## **NOTICE TO BIDDERS**

### **ADDENDUM #1**

Bid #CM-17-18-01-NEC-01-XX North Education Center Interim Village Project

### **Palomar Community College District**

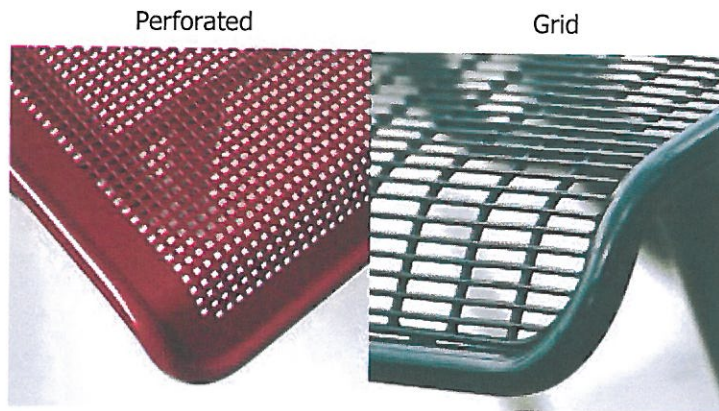
- (15) QUESTION: Bid Package D: 32.12.16, Please confirm all the following components of the asphalt concrete paving section are to be included in the proposal. Soil Sterilizer, Primer, Seal Coat, Headers

*RESPONSE: All components as specified shall be provided.*

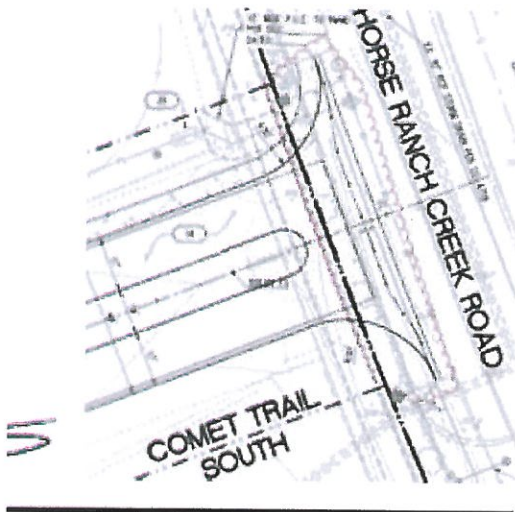
- (24) QUESTION: Bid Package D: L1-1.12, L-5.1, A1.22.2; 32.14.13, Sheet A1.22.2 calls for permeable pavers. Other plan and spec information is for non permeable pavers. Please confirm call outs for permeable pavers are incorrect, and pavers are to be non permeable.

- (25) QUESTION: Bid Package D: L1-1.12, L-5.1, A1.22.2; 32.14.13, Will pavers be subject to loading from construction equipment or delivery truck and trailers for construction of portable classrooms?

It is noted the minimal pedestrian type structural section for the pavers will not withstand equipment or vehicular loading.

*RESPONSE: See item #45 below for sequencing required for Interim Village hardscapes. Asphalt should be in place and modular units should be set (by others) before other hardscape scopes (which could be damaged by modular install) should proceed. Bid Package D contractor will be responsible for means and methods and sequencing of hardscapes to meet the critical modular installation dates.*

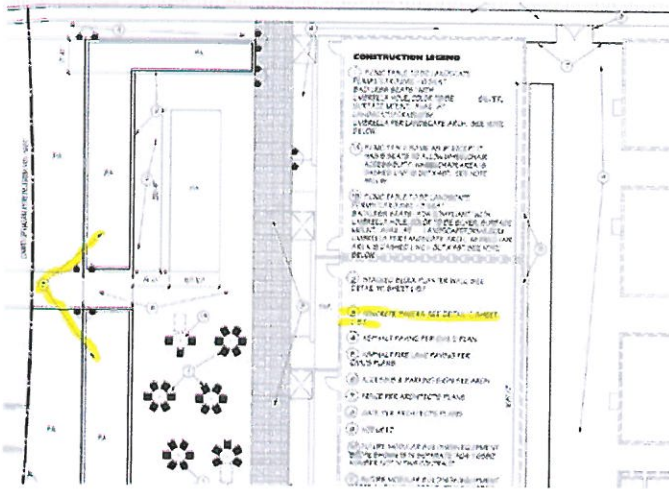
(47) Sheet L-1.12 incorrectly makes reference to pavers inside the planters at Interim Village (see snapshot below). There are NOT concrete pavers inside the raised block planters. Reference detail H on L-5.1 for details on planter construction. Bid Package D will construct the block planters and Bid Package F will provide filter fabric, soil, and planting.

# Addendum #1 - L4.3; Question #33

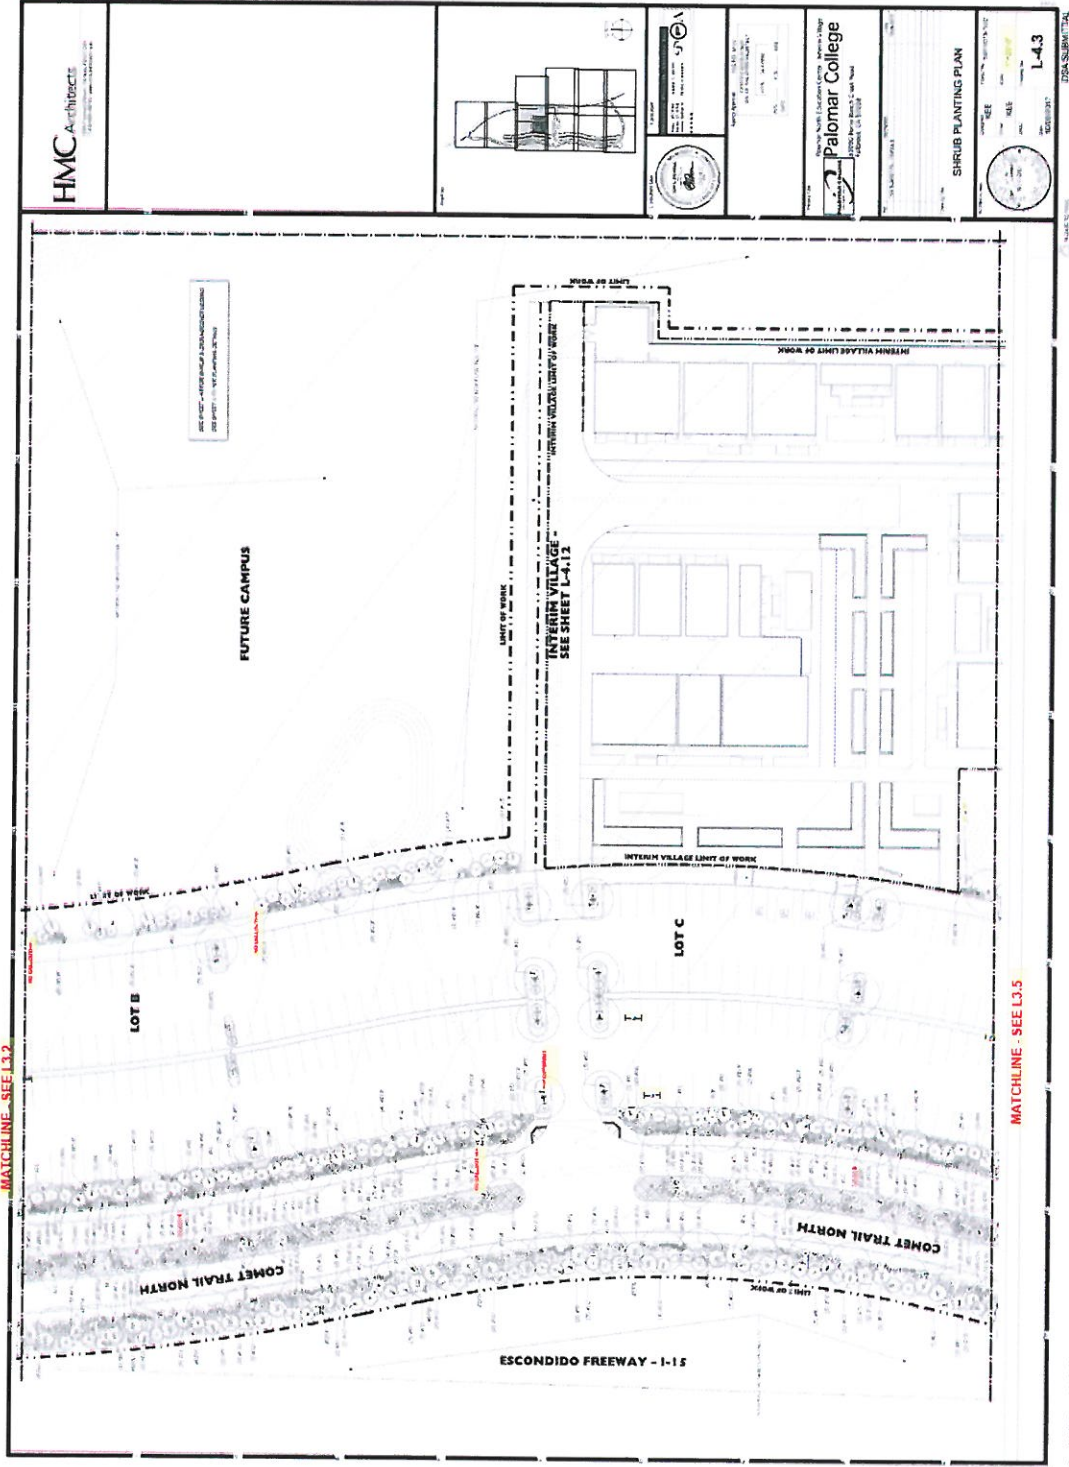
- (33) QUESTION: Please see attach plan pages, L-4.2, L-4.3, L-4.5, L-4.6, L-4.7, L-4.9, there are many shrubs identified on these pages that are missing call outs of the plant material variety. Please advise.

*RESPONSE: The plan sheets have changed quite a bit since the bid set went out, plants (trees, shrubs, groundcovers) have been revised and changed, see attached planting plan set. Reference Attachments B, C, D, E.*
